Service Bulletin No: 32-030

**LANDING GEAR - EXTENSION AND RETRACTION  
ELECTRO-MECHANICAL ACTUATOR CORROSION PROTECTION****1. Planning Information****A. Effectivity**

DOCUMENT:	Inspection of Actuator, Nose Landing Gear and Actuator, Main Landing Gear
NUMBER:	SB21-0001
ISSUE STATUS:	03
ISSUE DATE:	25/August/2022
FILENAME:	SB21-0001_03.docx

Figure 1

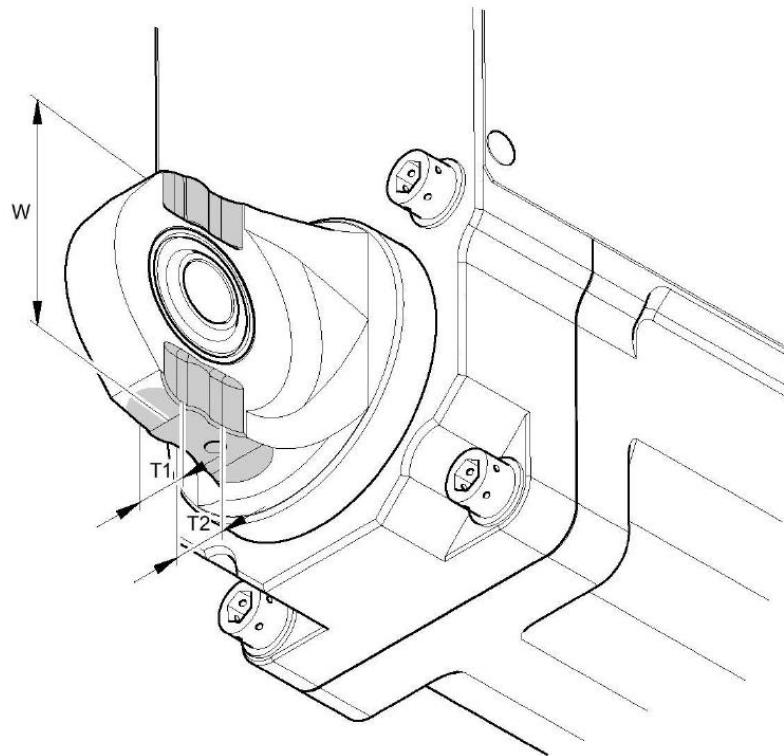
(4) Use adhesive tape (Mat. No. 12) to cover the actuator spherical bearing and the gap between the sliding head lug and the actuator housing to prevent particle ingress, refer to Figure 1.

(4) Remove the adhesive tape (Mat. No. 12), refer to Figure 1.

Figure 2

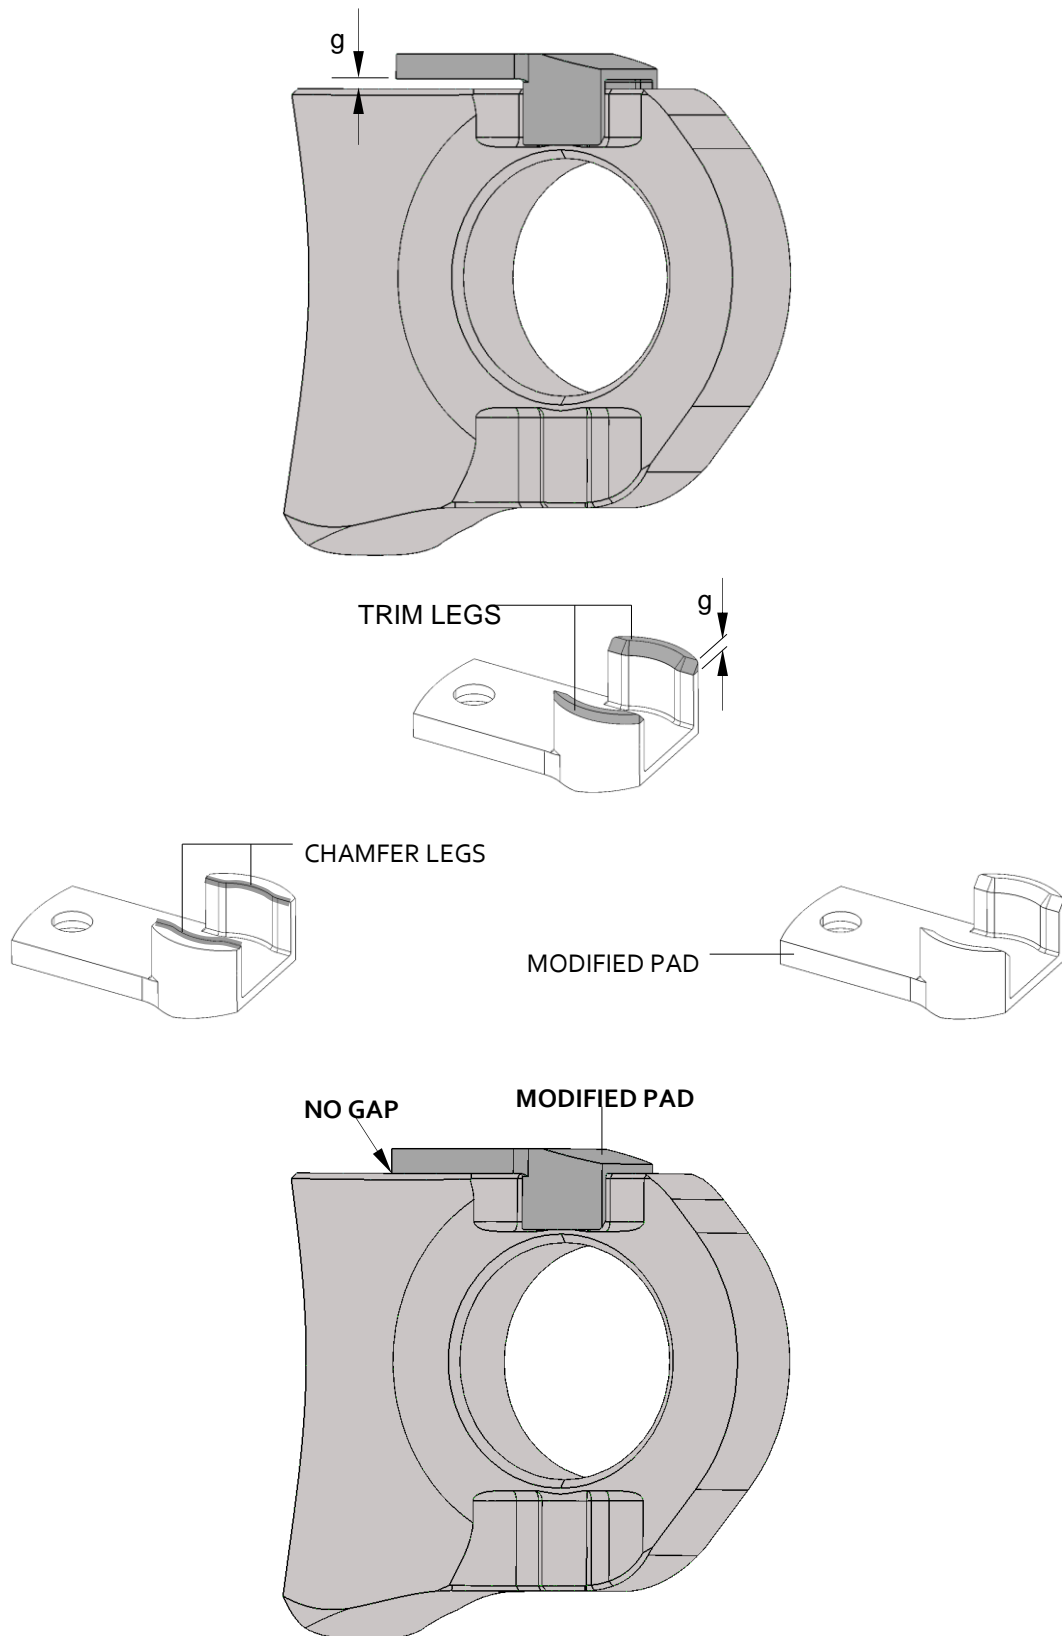
(2) Use a cloth (Mat. No. 06) and isopropyl alcohol (Mat. No. 01) to clean the areas on the actuator lugs where the anti-rotation pads were installed (grey shaded areas shown in Figure 2). If necessary, use a non-metallic bristle brush to help remove surface contamination in small radii.

(1) Visually inspect the actuator lugs at the contact surfaces for the anti-rotation pads and at the holes for the anti-rotation pad attachment screws (grey shaded areas shown in Figure 2).

(1) Use the calipers to measure the initial lug width ( $w$ ), refer to Figure 2.

- (6) Use the calipers to measure and record the minimal lug thickness ( $t_1$  and  $t_2$ ), refer to Figure 2. Contact the Pilatus Tech Support if the actuator is outside these limits:
  - MLG actuator: minimum thickness must be equal to or larger than 8.80 mm (0.346 in)
  - NLG actuator: minimum thickness must be equal to or larger than 5.80 mm (0.228 in).

(7) Use the calipers to measure and record the minimum lug width (w), refer to Figure 2. Contact the Pilatus Tech Support if the actuator is outside these limits:

- Each side of the slide head lug width must be reduced by less than 1.5 mm (0.059 in).
- The slide head lug minimum width must be equal to or larger than 44.4 mm (1.75 in).
- Each side of the gear housing lug width must be reduced by less than 1.5 mm (0.059 in).
- The gear housing lug minimum width must be equal to or larger than 41.4 mm (1.63 in).

- Each side of the slide head lug width must be reduced by less than 1.5 mm (0.059 in).
- Each side of the gear housing lug width must be reduced to less than 1.5 mm (0.059 in).
- The minimum width must be equal to or larger than 36.2 mm (1.43 in).

Figure 3

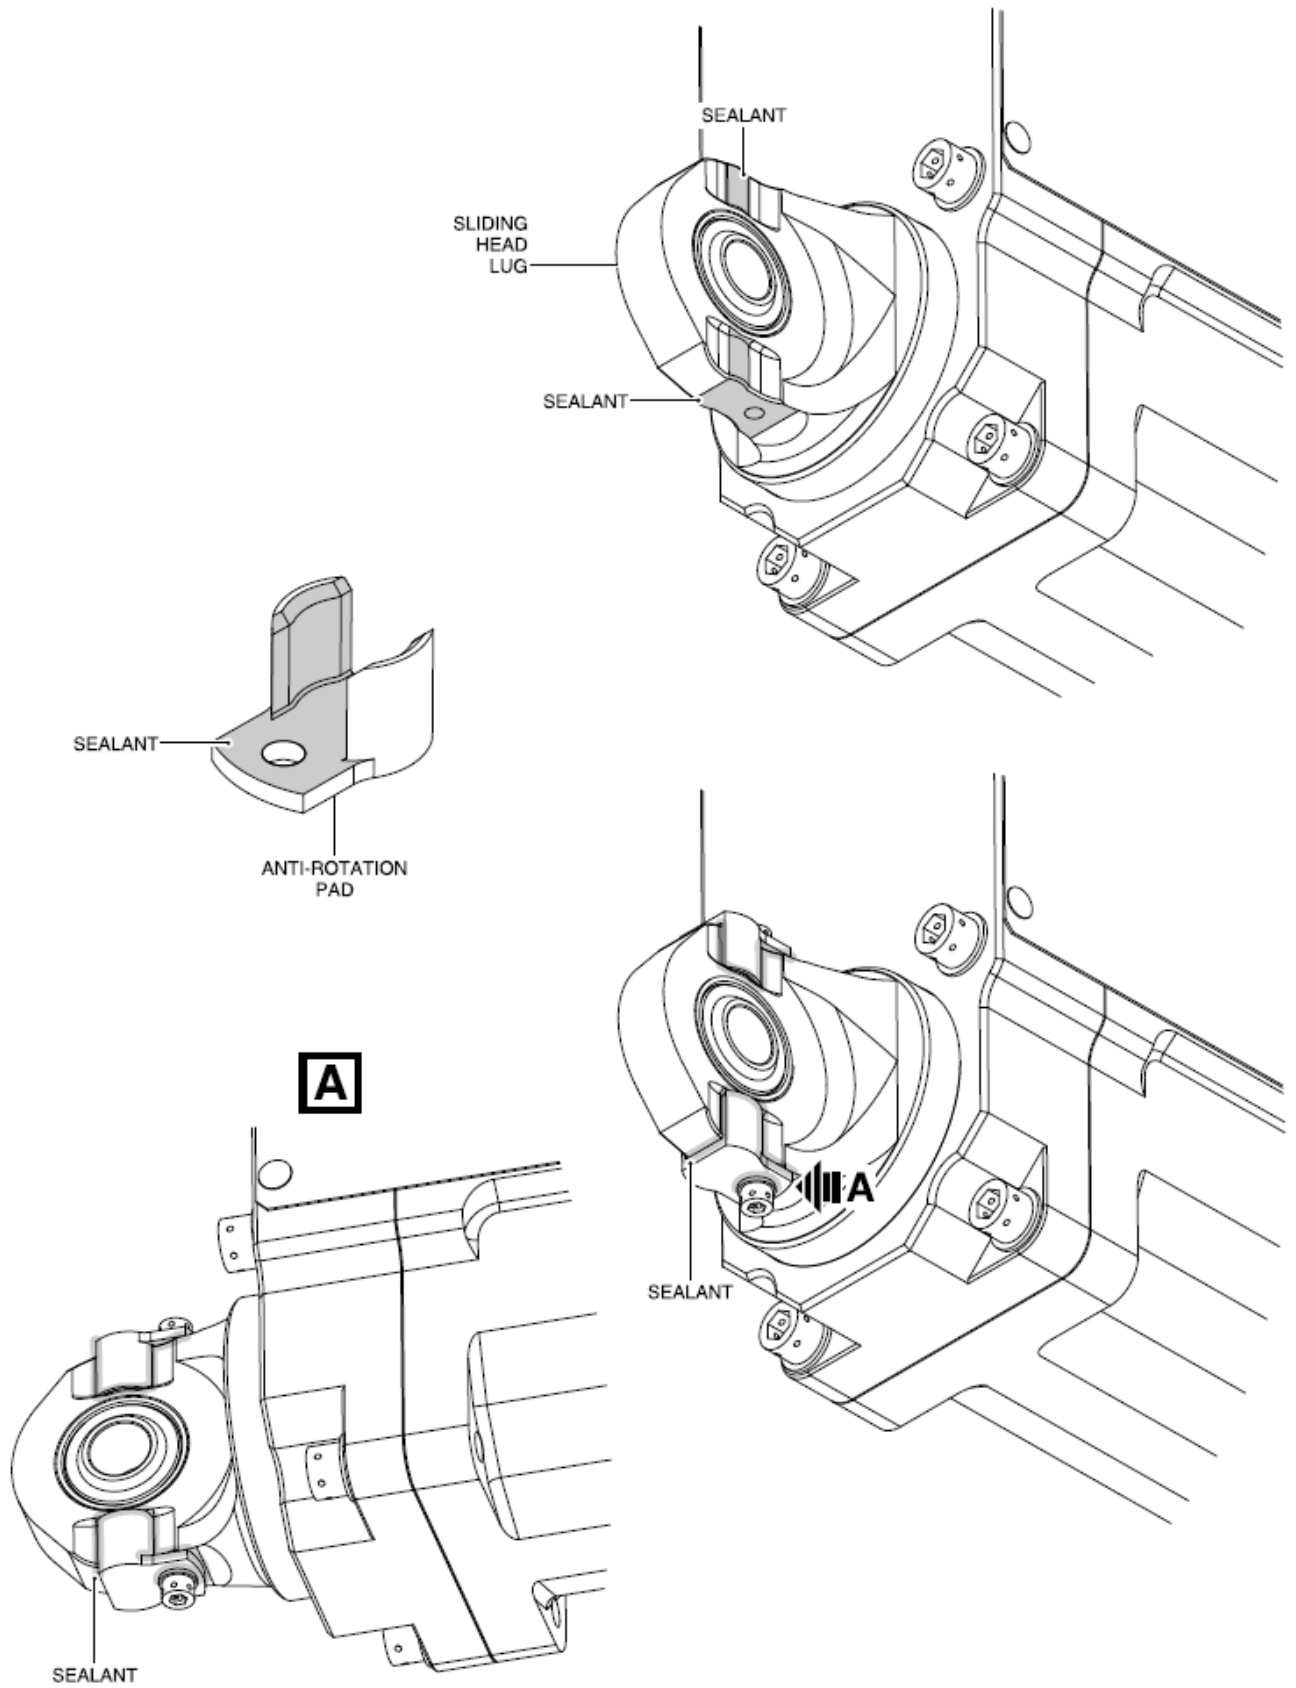
(9) If the lug width (w) has been reduced to remove the corrosion:

- a. Slide a new anti-rotation pad onto the lug.
- b. If there is a gap (g) between the anti-rotation pad and the lug, modify the anti-rotation pad as follows:
  - i. Shorten the 2 legs of the anti-rotation pad.
  - ii. Add a 1mm chamfer to the inner edges of the anti-rotation pad legs.
  - iii. If a gap remains, go back to Step (9)a.
  - iv. Deburr any sharp edges introduced by shortening the pad.
  - v. Apply a layer of epoxy primer (Mat. No. 08) on the reworked areas. Let the primer cure for 72 hours.

Figure 4

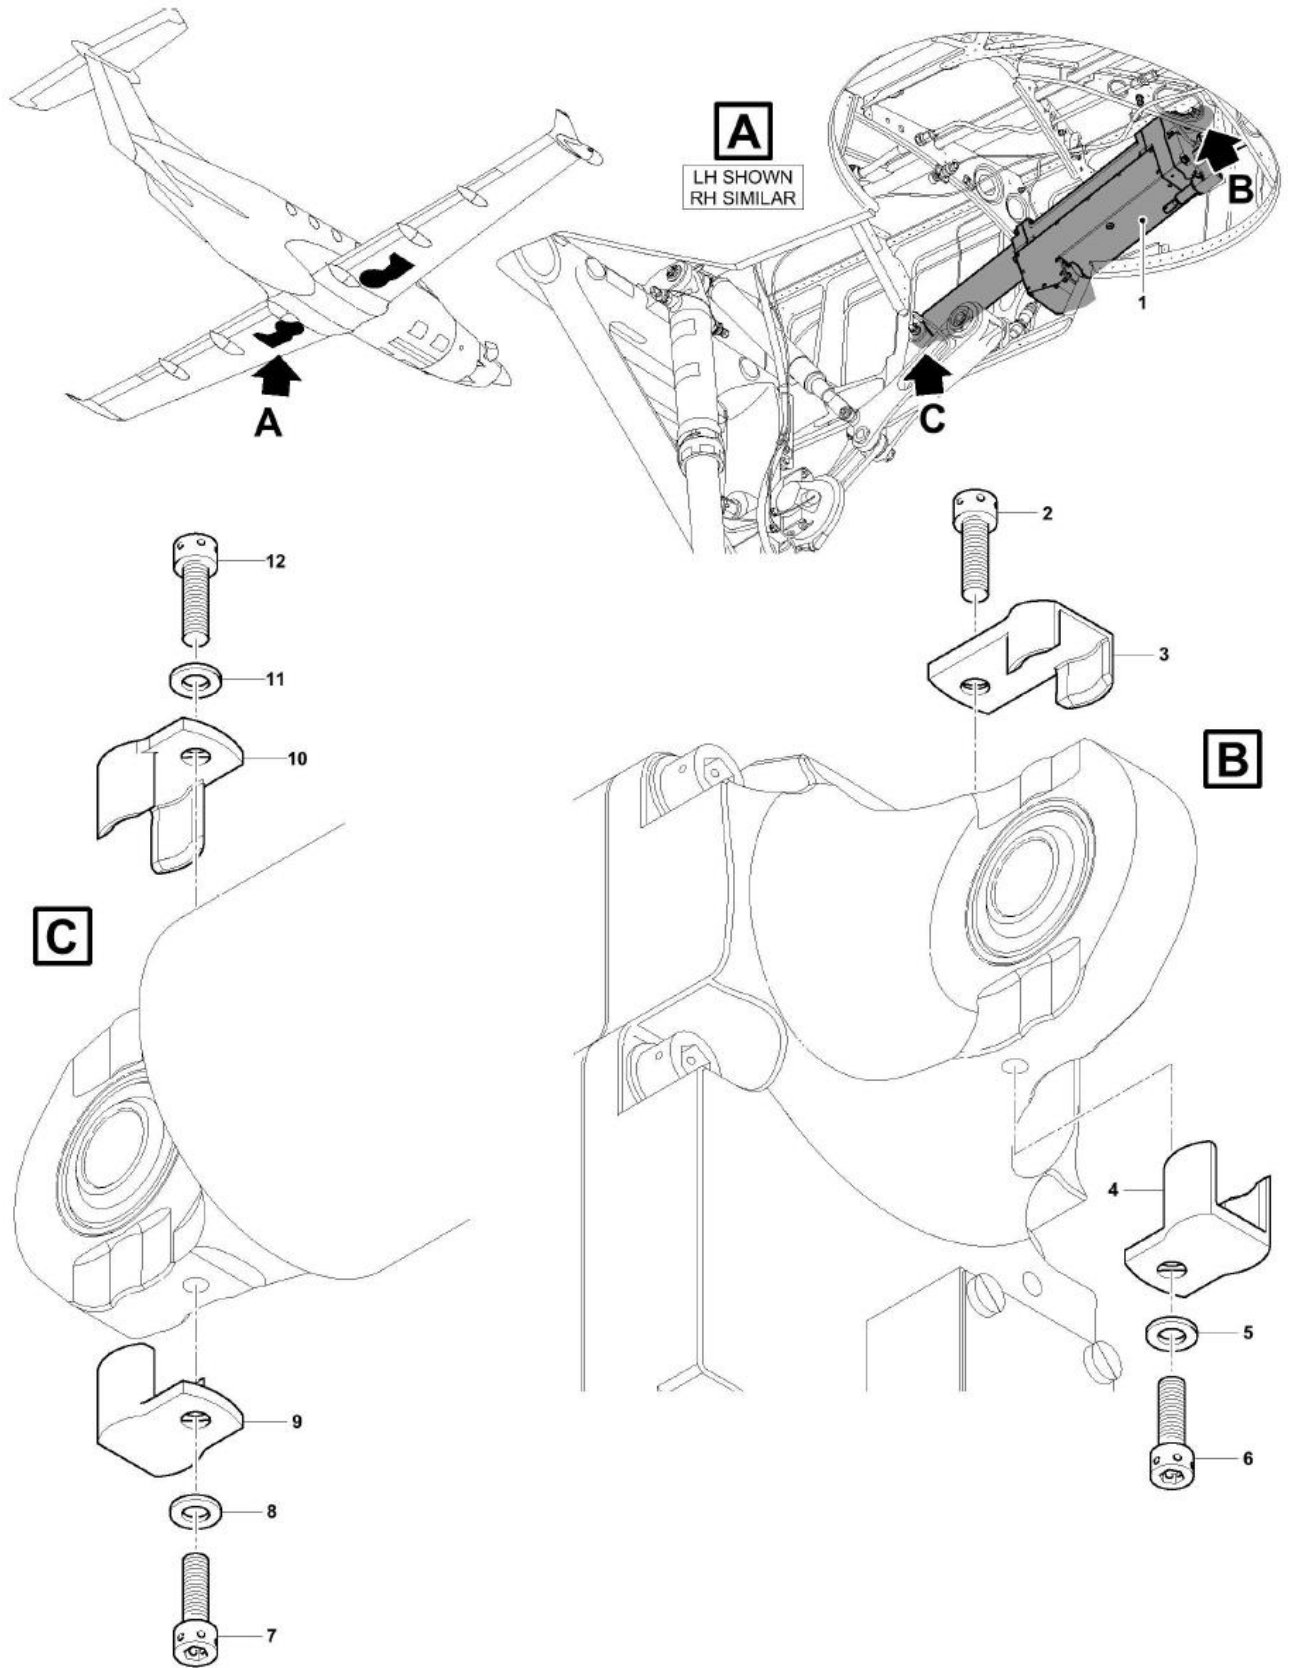
Refer to Figure 4, Figure 5 and Figure 6.

- a. Use sealant (Mat. No. 11) to cover the complete contact area between the anti-rotation pad and the actuator lug.

- b. Install the anti-rotation pads onto the actuator lugs.
- c. Make sure that the sealant is squeezed out all around the edge of the anti-rotation pads. If necessary, remove the anti-rotation pads to apply additional sealant.
- d. Install the screws and the washers to hold the anti-rotation pads, refer to Figure 5:

Figure 5

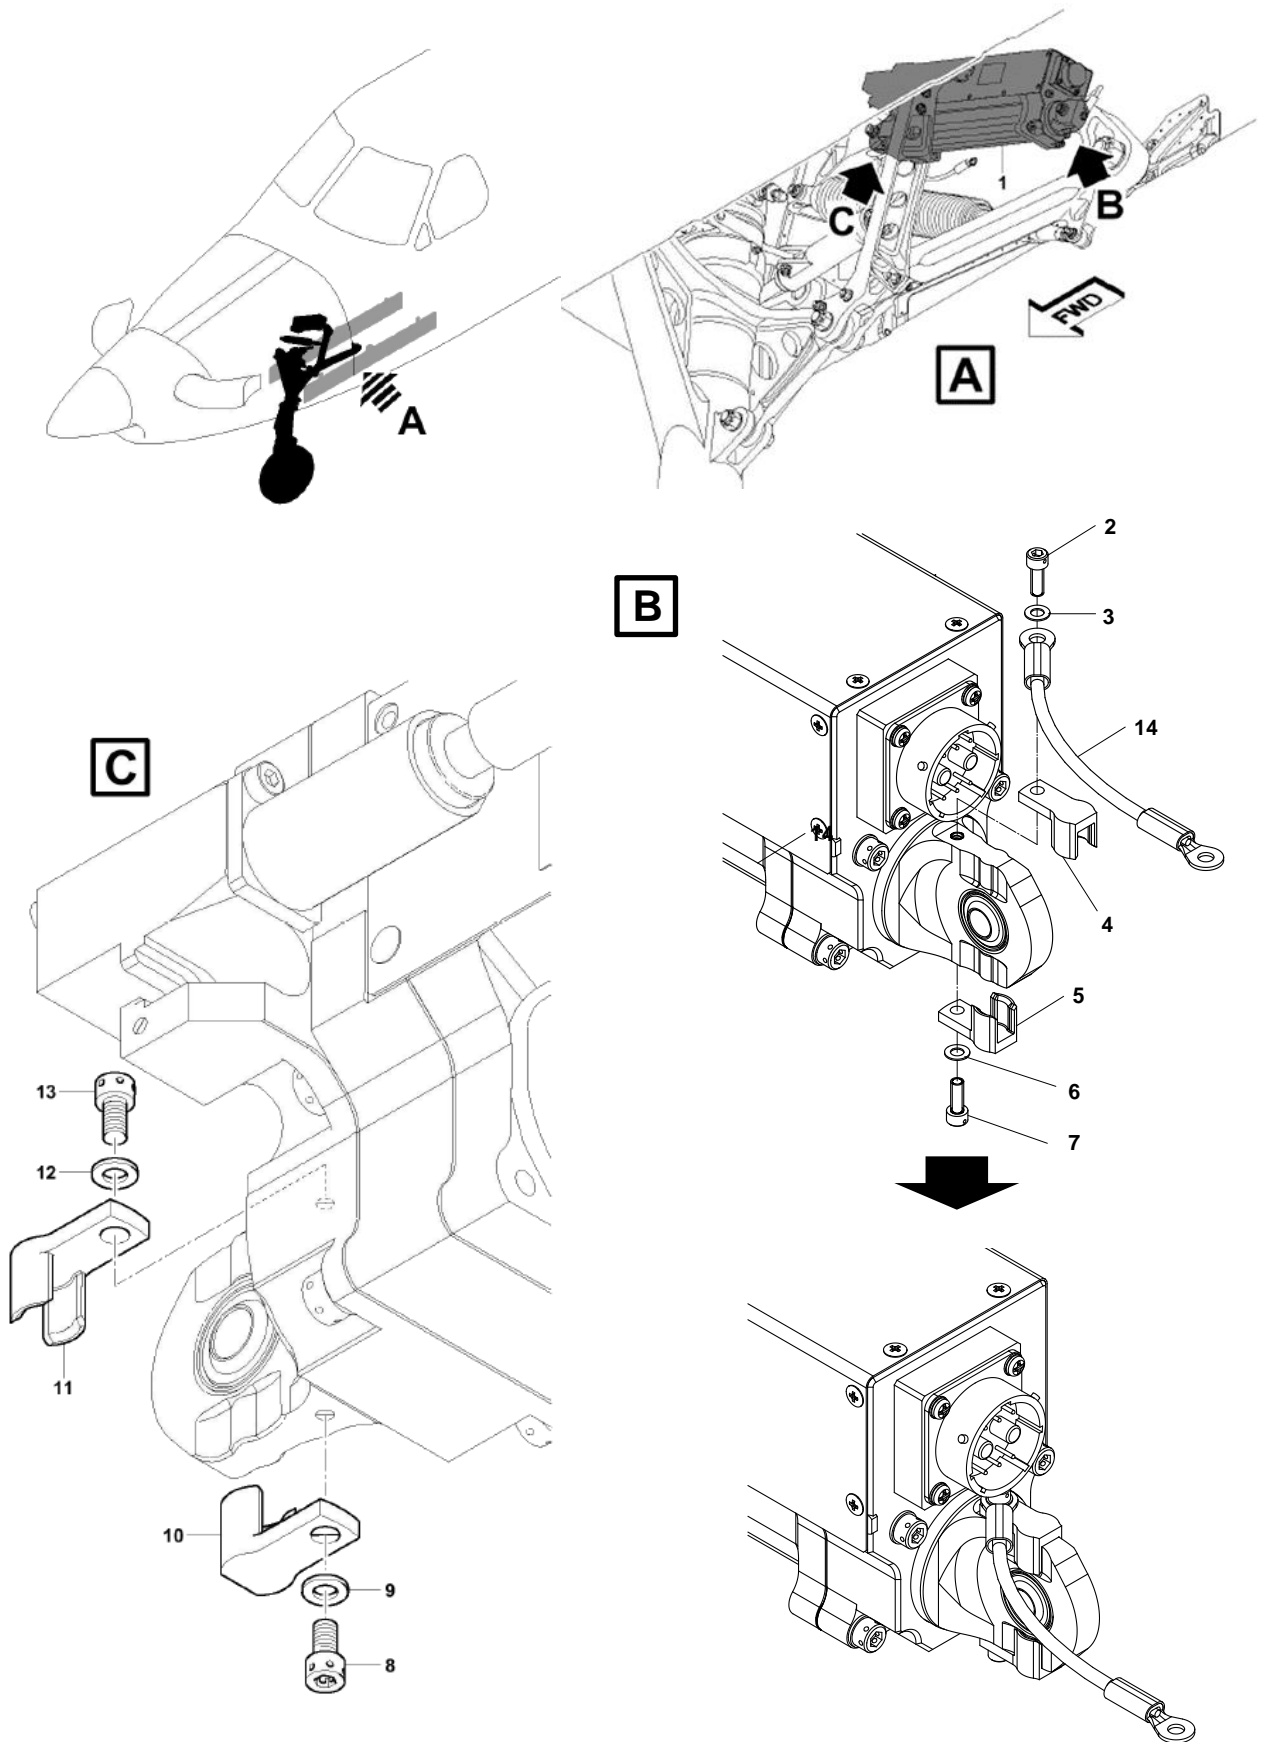
(1) Remove and discard the anti-rotation pad, the washer and the screw from the actuator, refer to Figure 5 and to Figure 6.

- i. Install the shorter screw (2) to hold the anti-rotation pad (3) on the actuator (1).

**NOTE:** On the MLG actuator, no washer is used for screw (2). All other screws have washers.

- ii. Install the screw (6) and the washer (5) to hold the anti-rotation pad (4).

- iii. Install the screw (7) and the washer (8) to hold the anti-rotation pad (9).

- iv. Install the screw (12) and the washer (11) to hold the anti-rotation pad (10).

e. Torque tighten the screws to 1.3 Nm  $\pm$ 0.13 Nm (11.5 lbf in  $\pm$ 1.15 lbf in).

Figure 6

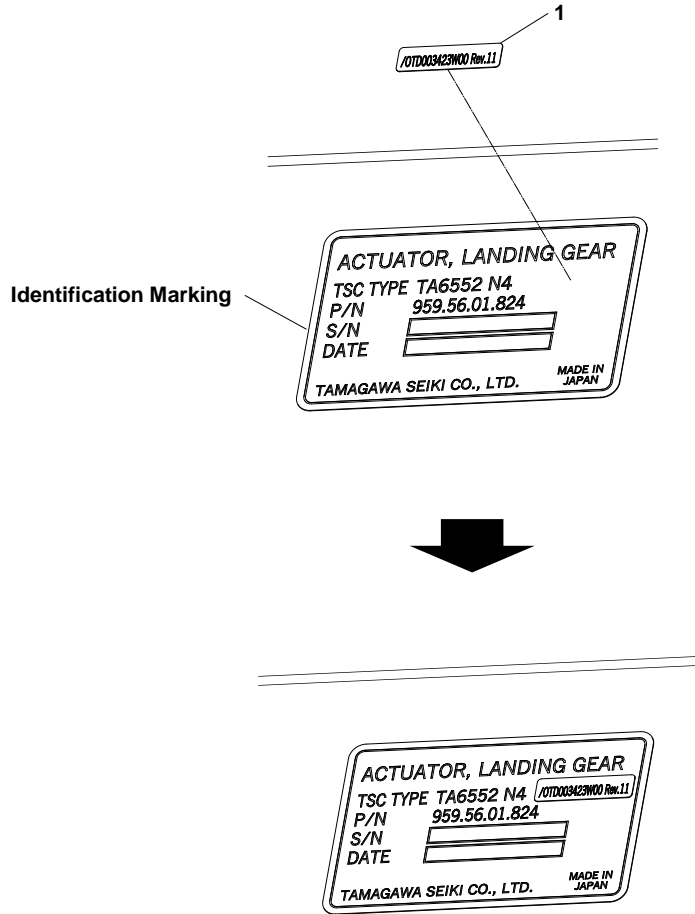
**WARNING:** Do not apply epoxy primer at the contact area with anti-rotation pad 4 (See Figure 6, Item 4). Epoxy primer being non-conductive, the proper bonding of this surface to the anti-rotation pad and the bonding strap will be lost.

**NOTE:** The Step a. applies only to the anti-rotation pad (Figure 6, item 4) to be installed on the NLG actuator, Slide Head connector side.

**NOTE:** The Step b. applies to the three other anti-rotation pads (Figure 6, item 5, item 10 and item 11) to be installed on the NLG

- c. Install the anti-rotation pads onto the actuator lugs.
- d. Make sure that the sealant is squeezed out all around the edge of the anti-rotation pads. If necessary, remove the anti-rotation pad to apply additional sealant.
- e. install the screws and the washers to hold the anti-rotation pads, refer to Figure 6:
  - i. Install the screw (2), the washer (3) and bonding strap (14) [PN: 523.60.09.074] to hold the anti-rotation pad (4) on the actuator (1).

**NOTE:** The bonding strap must be installed with an angle of 45° from the centreline of the actuator.

- ii. Install the screw (7) and the washer (6) to hold the anti-rotation pad (5).
  - iii. Install the screw (8) and the washer (9) to hold the anti-rotation pad (10).
  - iv. Install the screw (13) and the washer (12) to hold the anti-rotation pad (11).
- f. Torque tighten the screws to 1.3 Nm  $\pm$  0.13 Nm (11.5 lbf in  $\pm$  1.15 lbf in).
- g. Remove excess sealant while it is still soft with a non-metallic scraper.
- h. Apply a fillet of sealant (Mat. No. 11) around the edge of the anti-rotation pads, around the screw heads and washers and around the bonding strap.
